Agency: Nuclear Regulatory Commission
Advisory Committee on Reactor Safeguards

Title: Subcommittee Meeting on Advanced Boiling
Water Reactors

DATE: Tuesday, January 25, 1994

Figure 2.6.2 Fuel Pool Cooling and Cleanup System

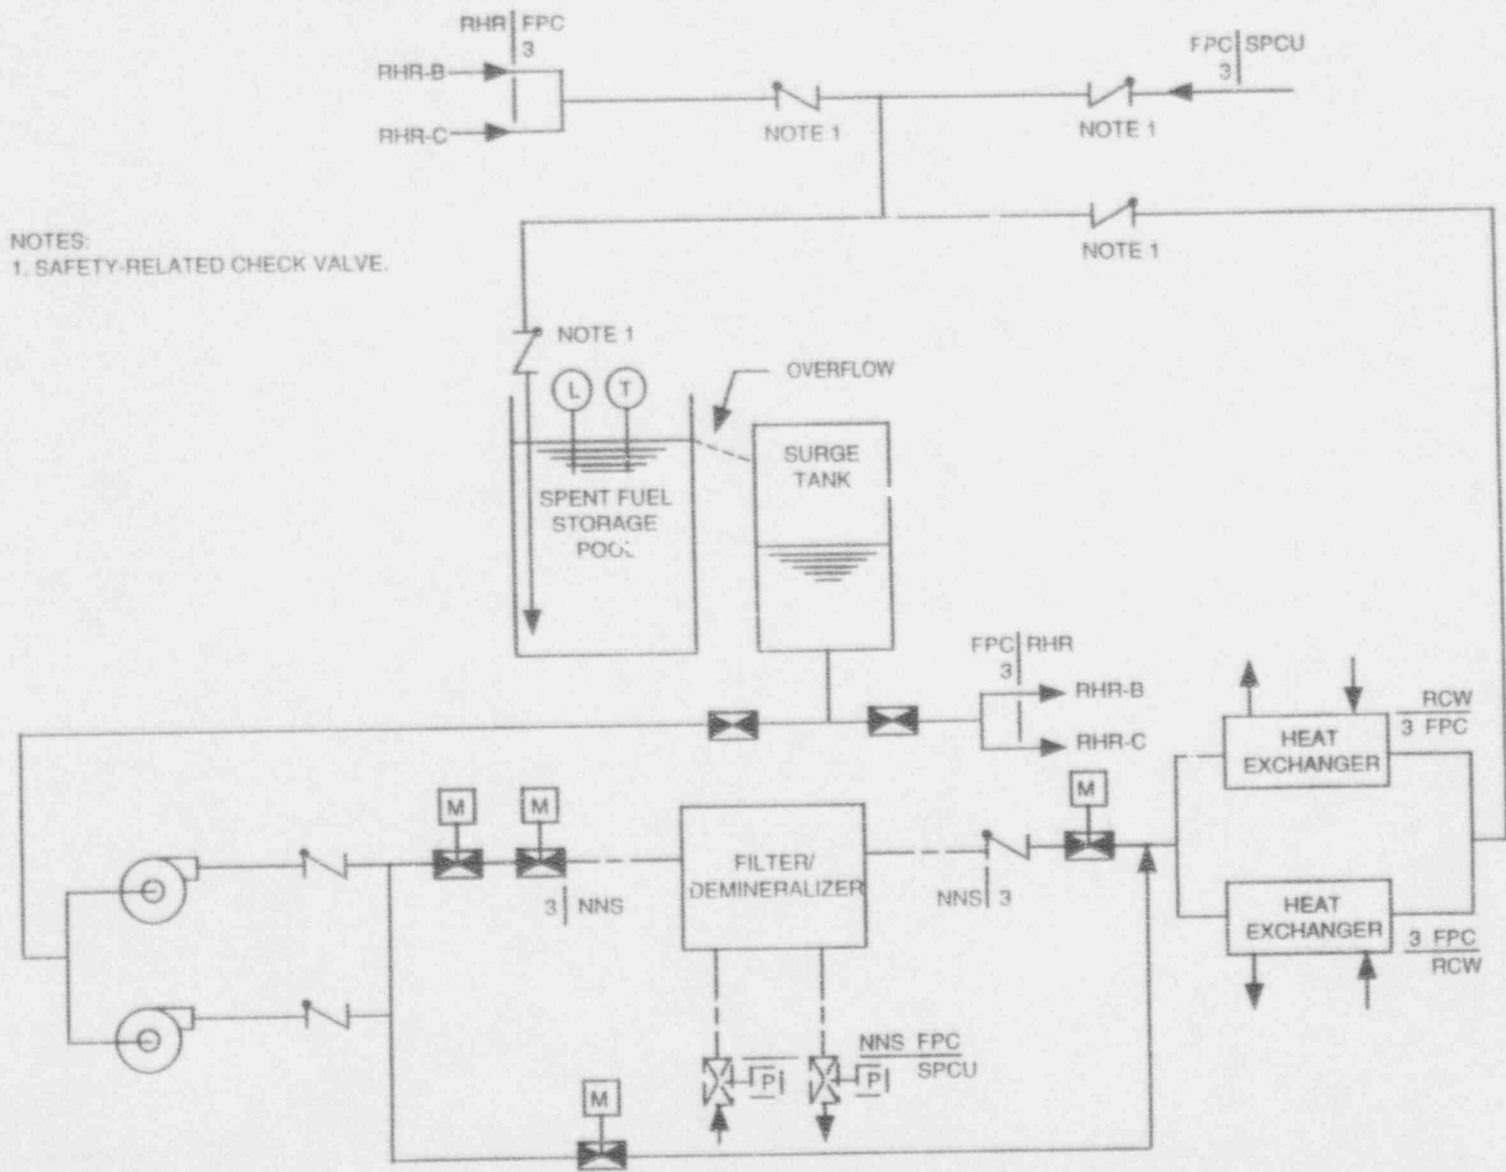
3 MR. MICHELSON: It would be important to know
4 that. I had a concern about that same line and was going to
5 ask you a question, which I guess is as good a time as any,
6 and that is that, if you were to rupture that common piping
7 and the check valve didn't hold, I'm not sure that check
8 valve even gets any kind of surveillance.

COL APPLICANT TO PROVIDE ADDITIONAL FEATURES TO PROTECT COMMON PIPING

12 MR. BURTON: All right. And then the only other
13 aspect that we added was, depending on the exact piping
14 layout, we do have a COL action item that they will provide
15 any additional features to protect that section of piping
16 from --

Figure 2.11.9a Reactor Service Water System

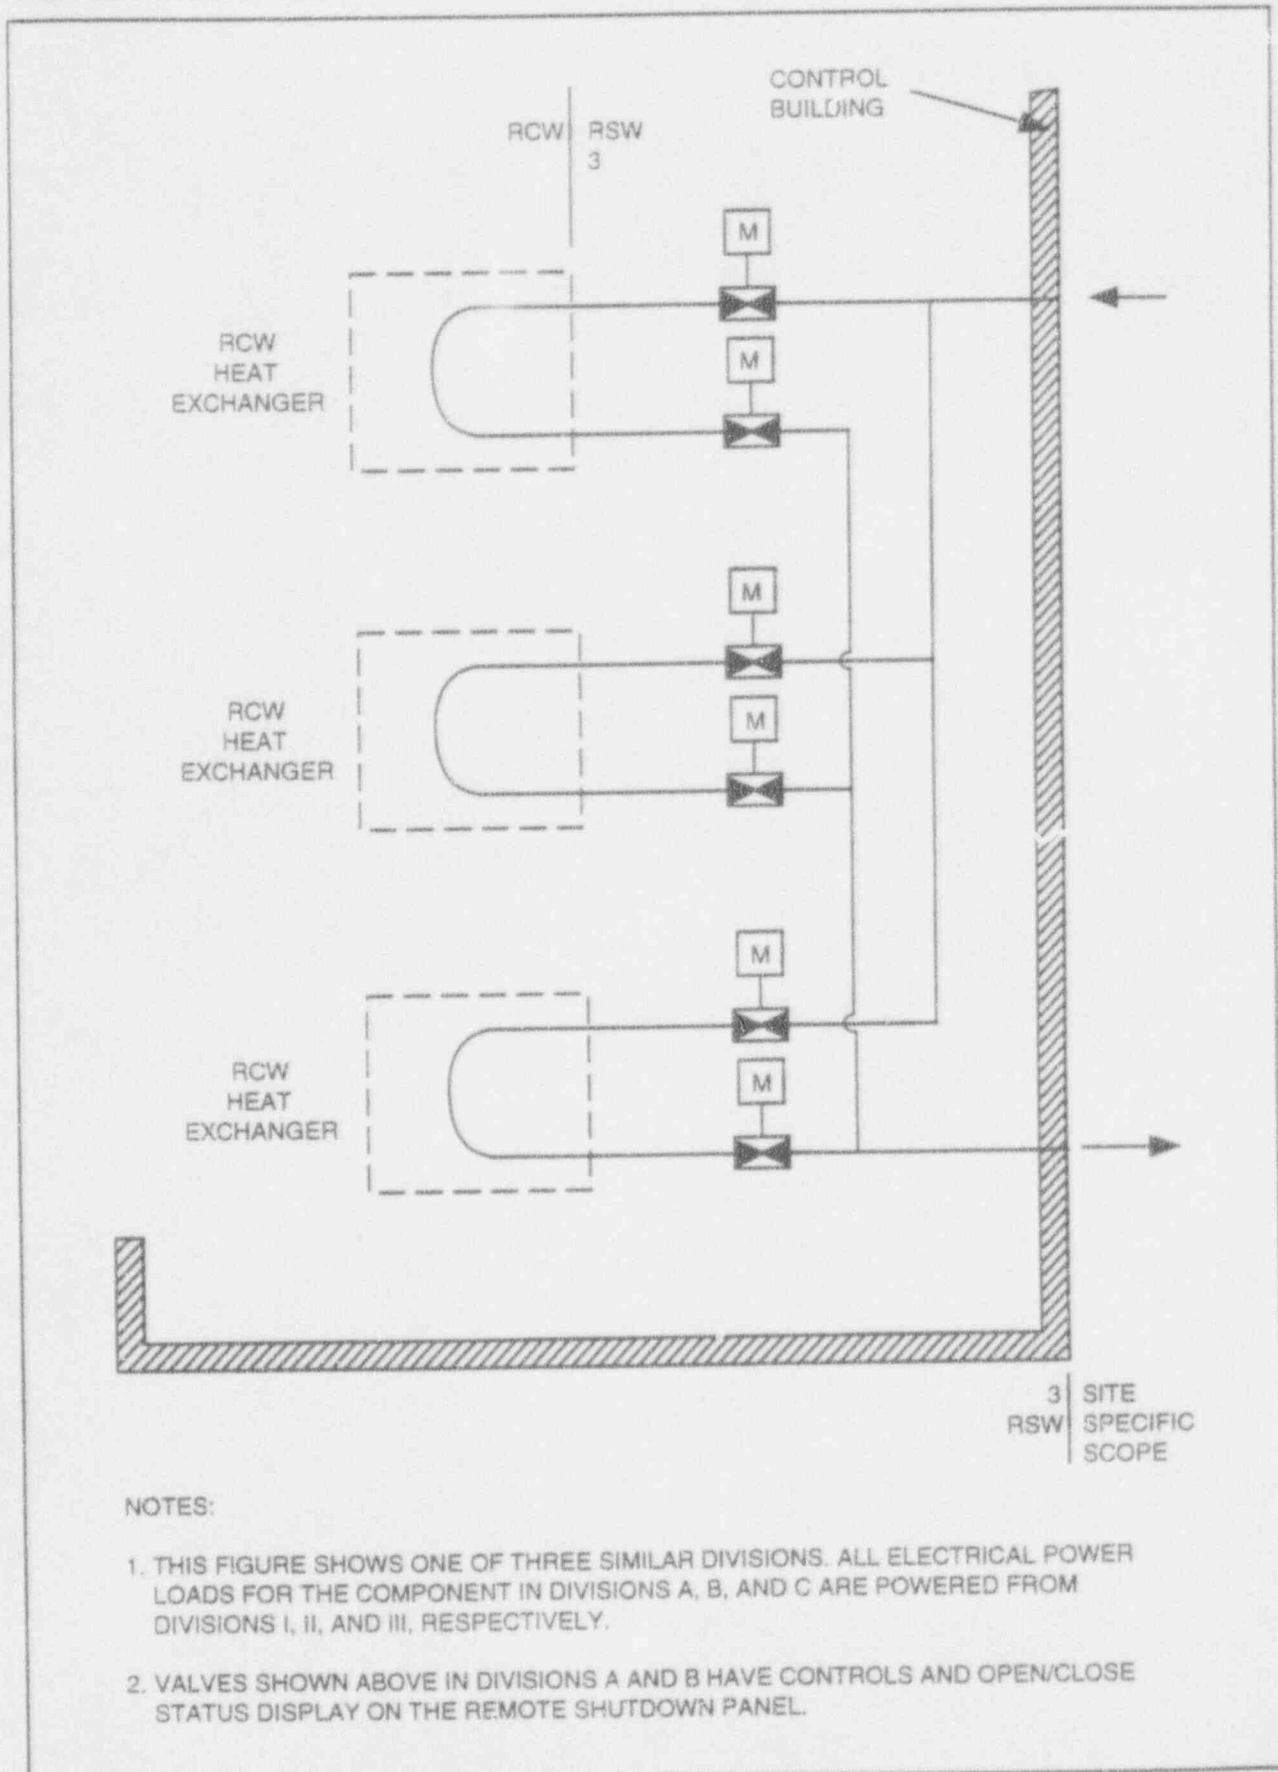
1 ultimate heat sink to reactor service water. I wanted to
2 show you how we treat a system that's partially in and
3 partially out at the Tier 1 level.

10 From the point that it enters the control
11 building, this system is in scope and has to be treated as
12 such. For that part of the system that's outside the
13 building -- and the reason it's in scope is because the
14 control building is in scope. For that part of the system
15 that's outside of the building, that is out of scope, and we
16 make that designation here. Inside is RSW system, outside
17 is site-specific scope. So, we don't have -- in Tier 1, we
18 don't have any of the design detail for anything out here,
19 but we do have it here.

23 MR. BURTON: That's correct. But we do have an
24 interface requirement. Okay. For instance, specifically
25 for the control building, if you remember from Chapter 3,
